## GIG HARBOR FIRE AND MEDIC ONE

### GIG HARBOR STATION 51

#### ADDENDUM #01

September 5, 2025

5 ENLARGED RCP - TRAINING ROOM  
1/4" = 1'-0"

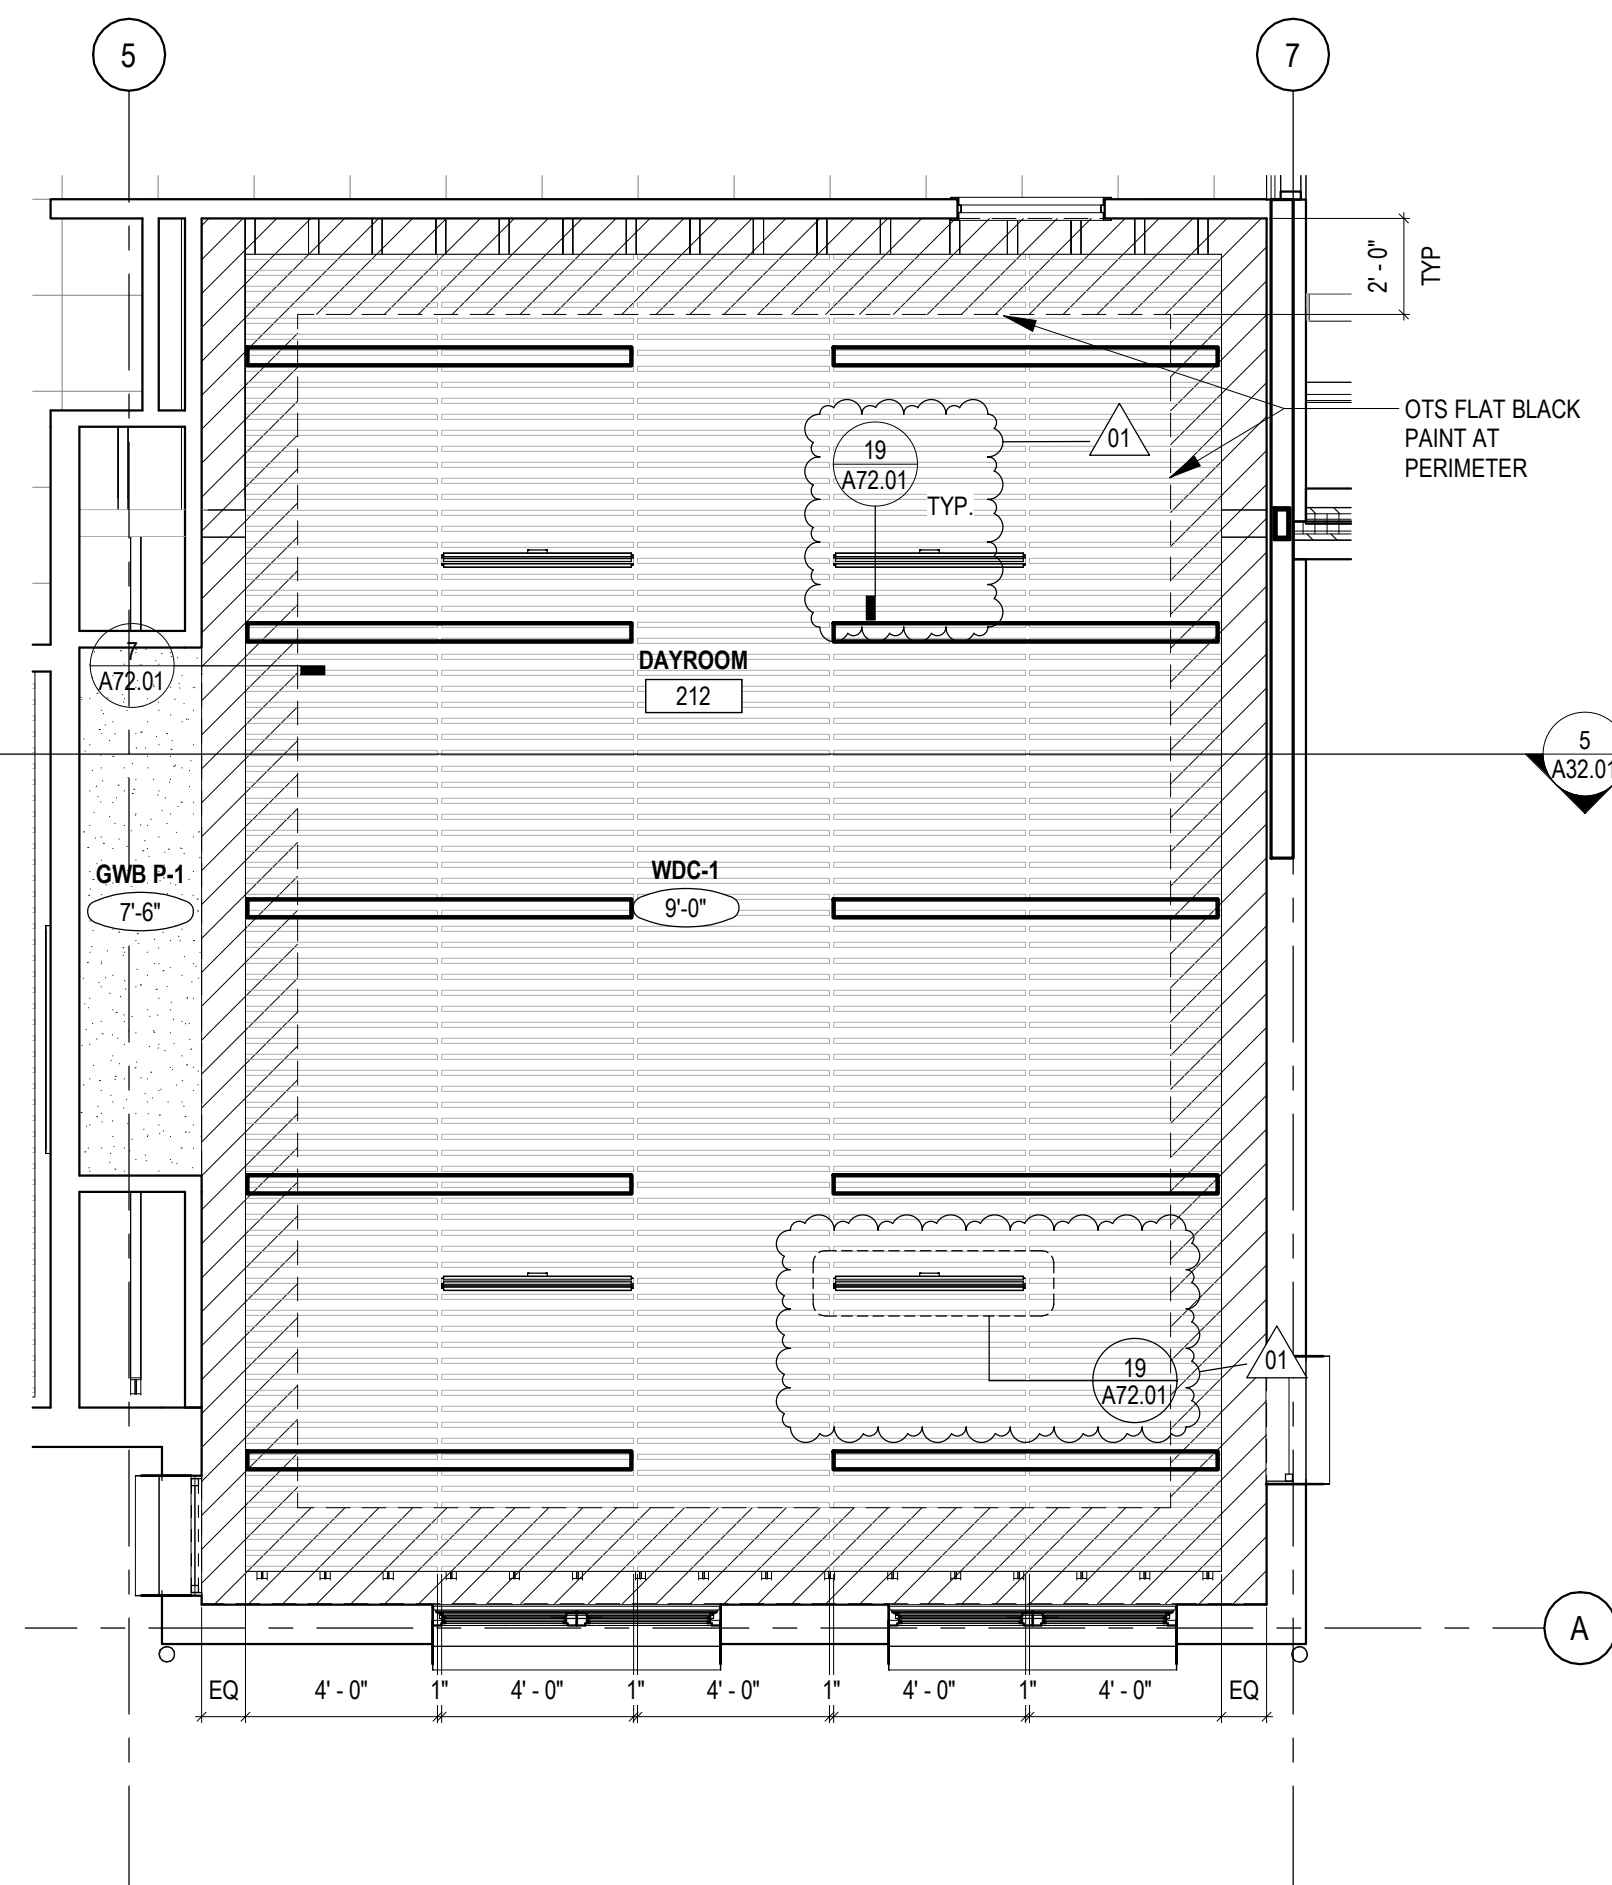
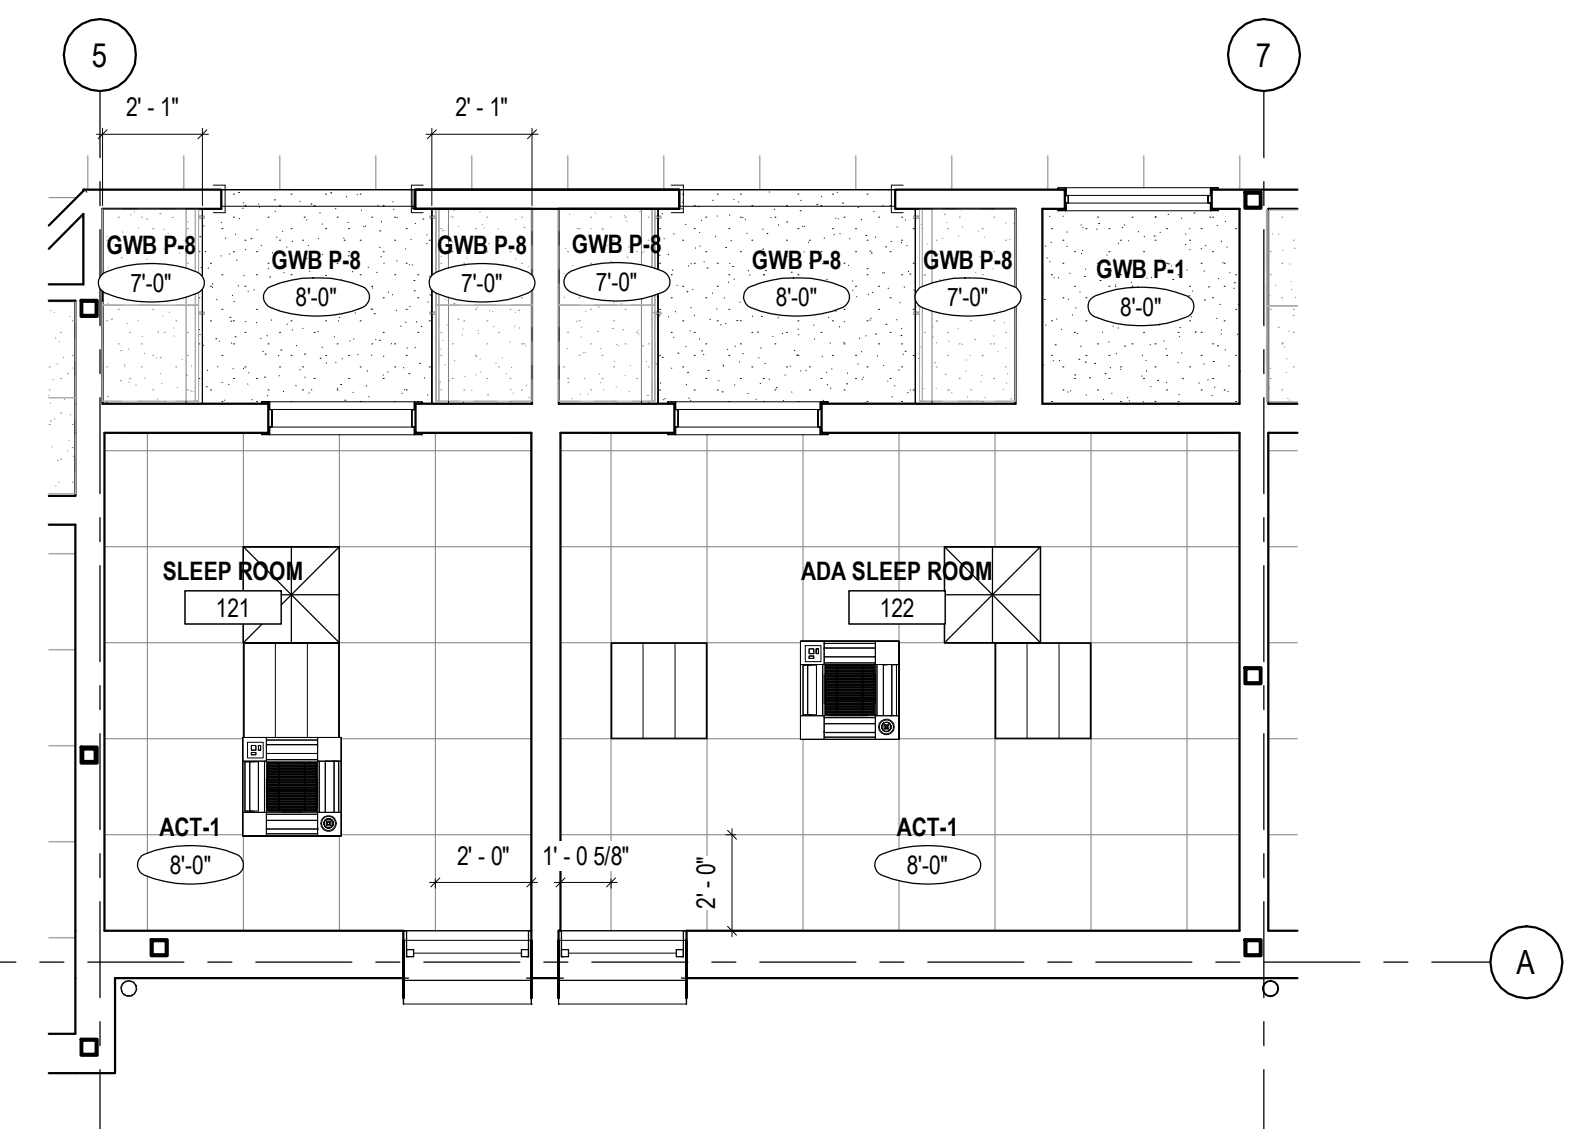
- ITEM 6** A00.01 – PROJECT INFORMATION, VICINITY MAP, PROJECT DESIGN TEAM: Revise "PROJECT DESIGN TEAM, ELECTRICAL ENGINEER" to "CHUCK HEATON, [caheaton@gftinc.com](mailto:caheaton@gftinc.com)," and "OLEG CHEROV, [okcherov@gftin.com](mailto:okcherov@gftin.com)." Note, phone number remains as listed.
- ITEM 7** C0.00 – COVER SHEET: **Added** sheet C03.03 to sheet index, **revision** to instructions for pre-construction meeting, revision to legend, and **revision** to site plan (see attached).
- ITEM 8** L01.00 – PLANTING PLAN: **Revision** to plant layout at NW and SE corners, revisions to notation along frontage (see attached).
- ITEM 9** L03.00 – IRRIGATION PLAN: **Revision** to irrigation layout at NW corner (see attached).
- ITEM 10** A28.01 – ENLARGED REFLECTED CEILING PLANS

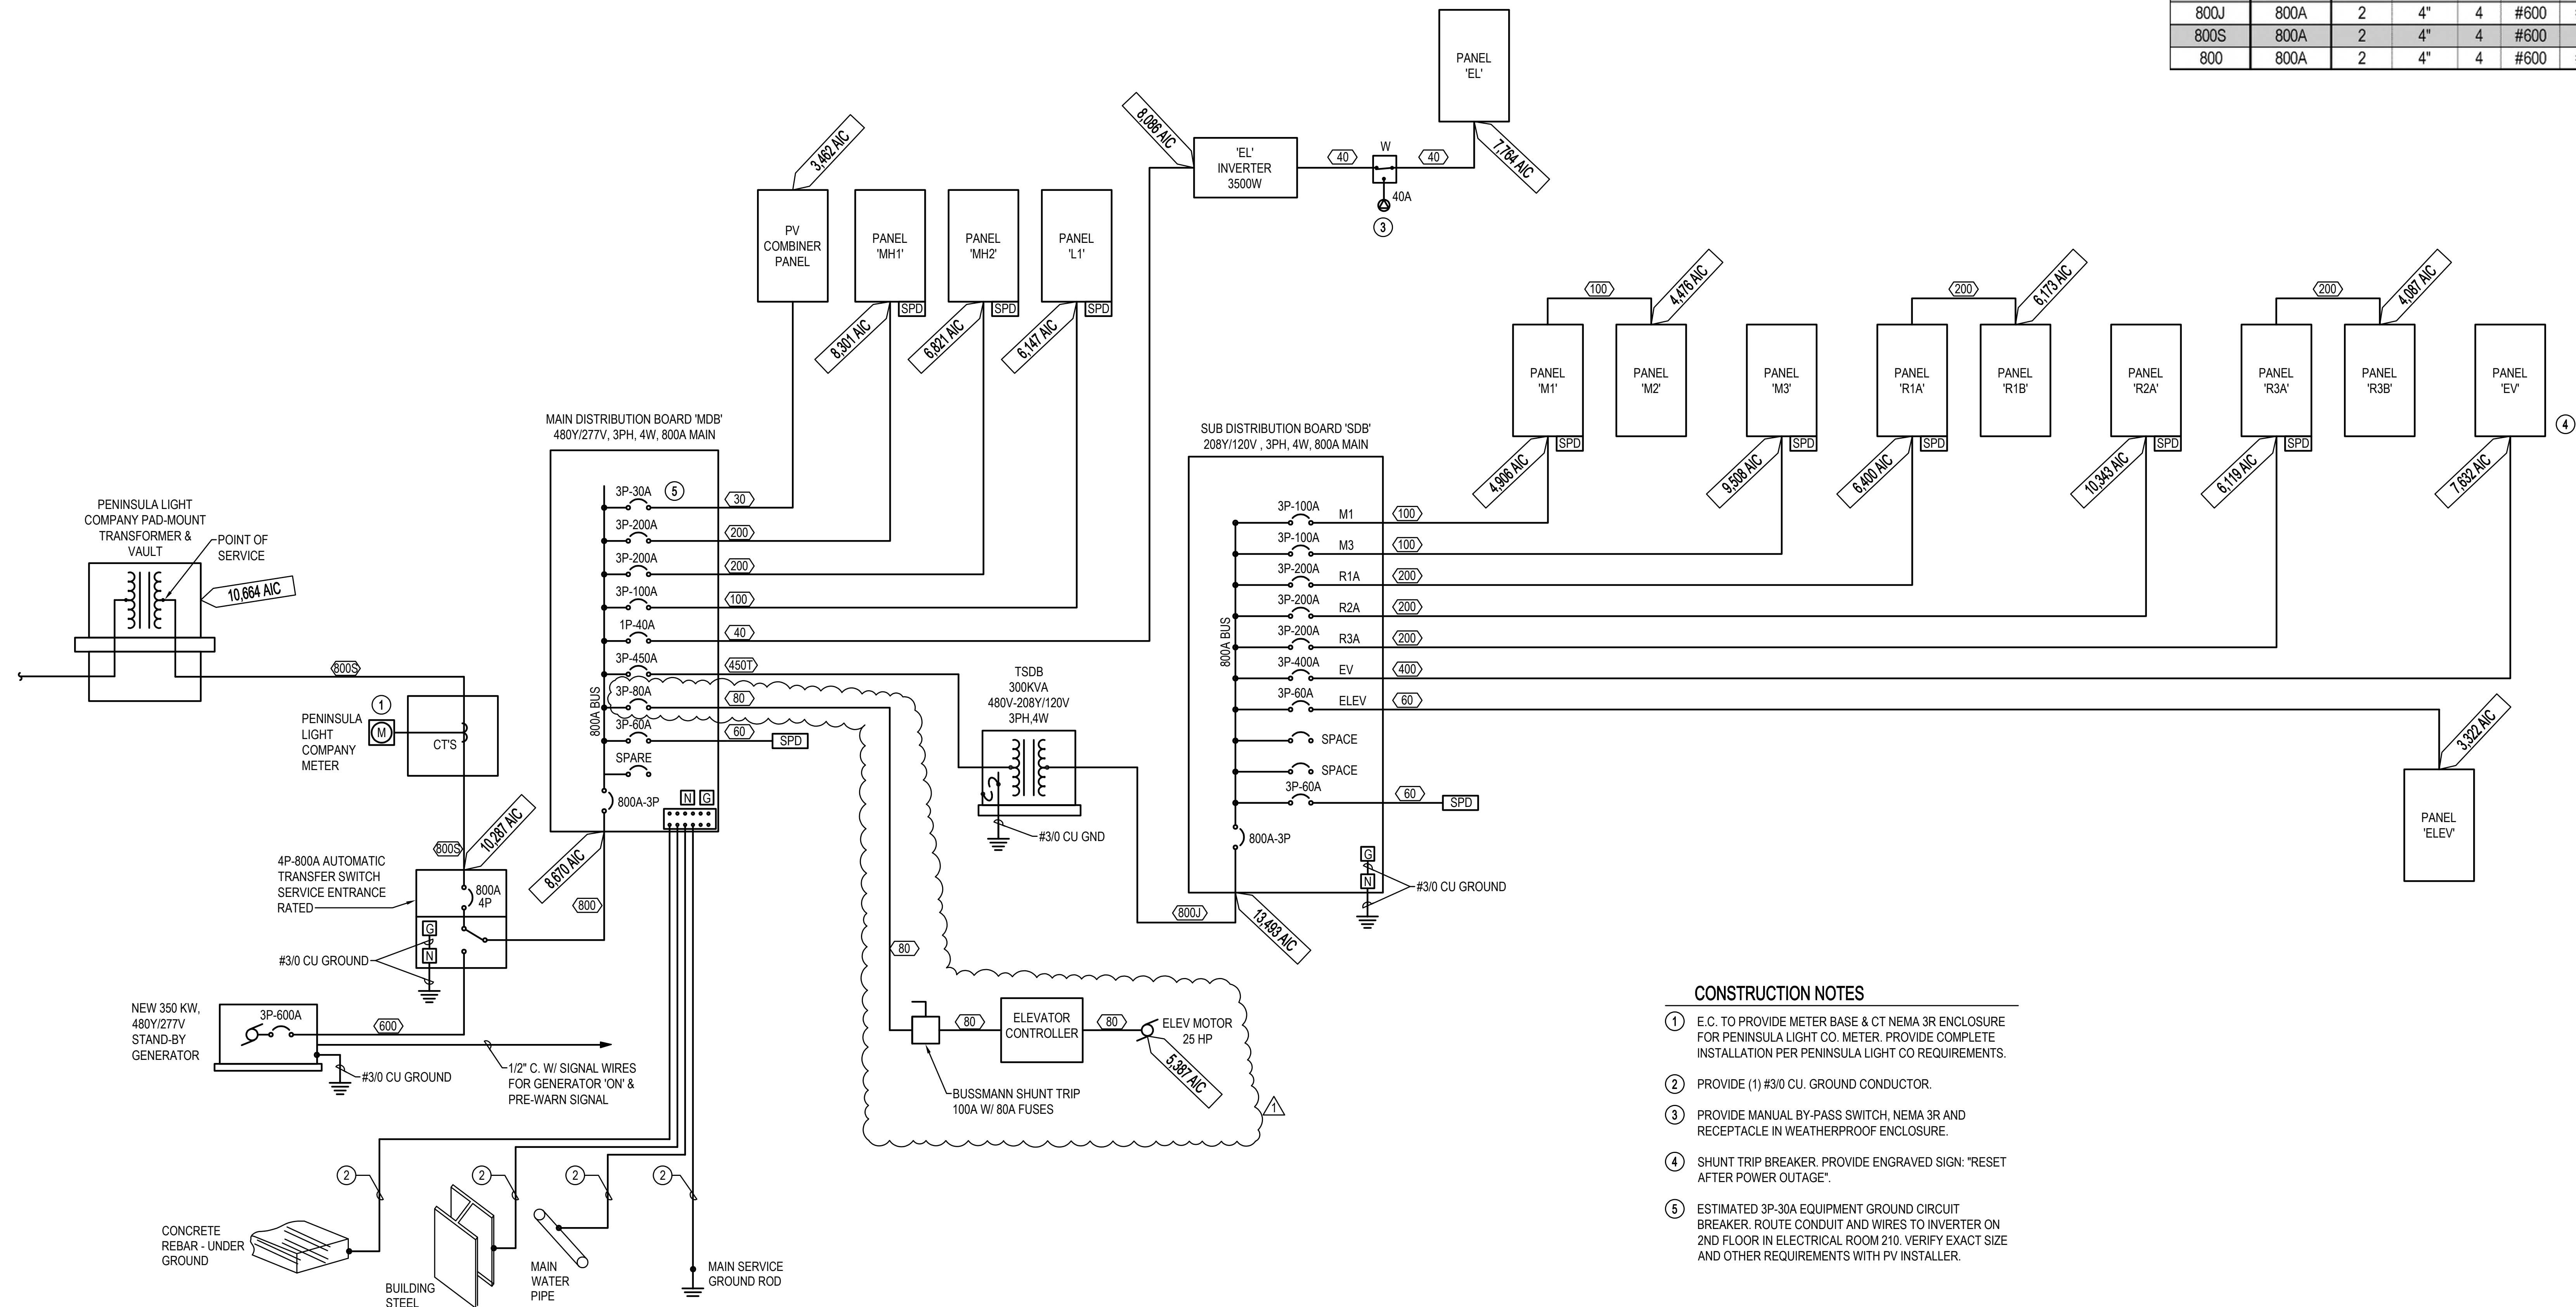
- ITEM 11** A72.01 – CEILING DETAILS  
**ITEM 12** P00.03 – SCHEDULES: **Revise** schedule per PSK-1  
**ITEM 13** E11.01 – ELECTRICAL SITE PLAN: **Revise** the flagpole light location; lighting fixture layout at the fuel canopy; and j-box location for hot box (see attached).  
**ITEM 14** E61.00 – ONE-LINE DIAGRAM: **Revise** feeder and circuit breaker size for the elevator and add feeder size to the feeder schedule (see attached).
